12 April 2023
21-064/ER

**(SDCC REF SD22A/0424) – HSE NATIONAL AMBULANCE BASE
REQUEST FOR FURTHER INFORMATION – ITEM #2**

Figure 4 – Drawing Extract Showing Car Parking

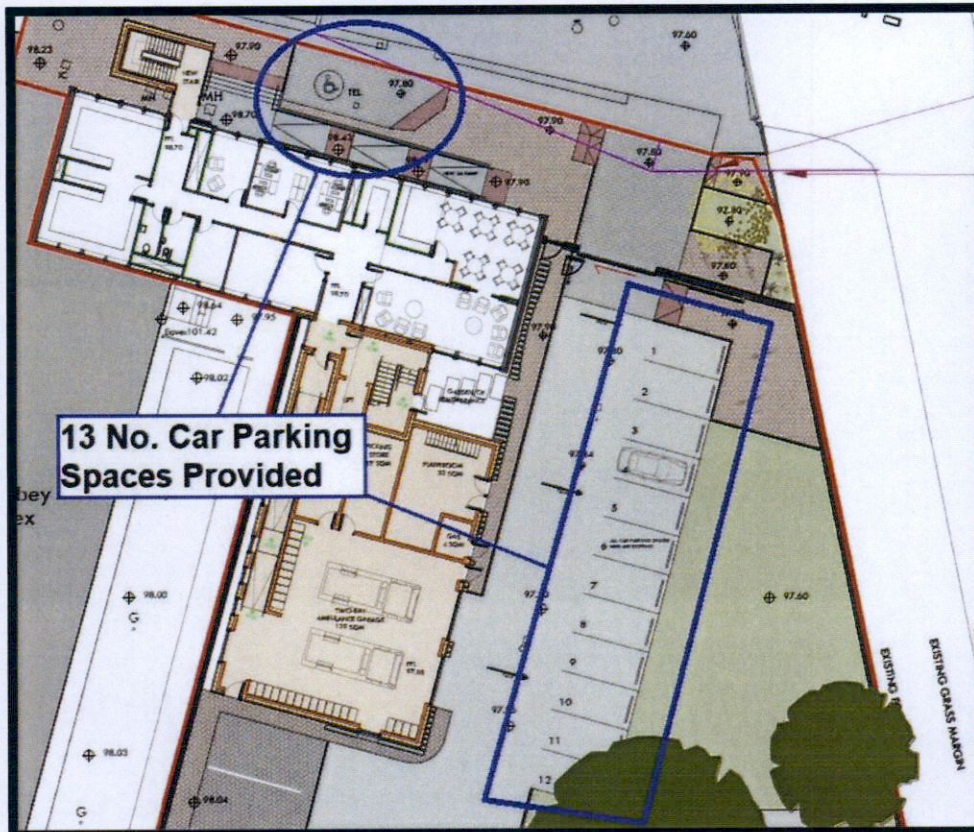
- c. A rationale explaining the reasoning for the proposed number of staff parking spaces (based on number of staff/drivers), with reference to the maximum parking rates allowable per Chapter 12 of the Development Plan.

If we assume a maximum staff number of 20, and allow for an overlap of 5 of these staff at shift change times, that would indicate a maximum staff number on site of 25 at the point of 'shift' overlap.

Applying a reasonable commuting car-occupancy rate of 2.0 (to account for drop-offs, car-share and also active travel modes), this results in a car parking requirement of 12-13 spaces.

A total of 13 parking spaces (including an accessible space) are provided as illustrated in the drawing extract included as **Figure 4** below.
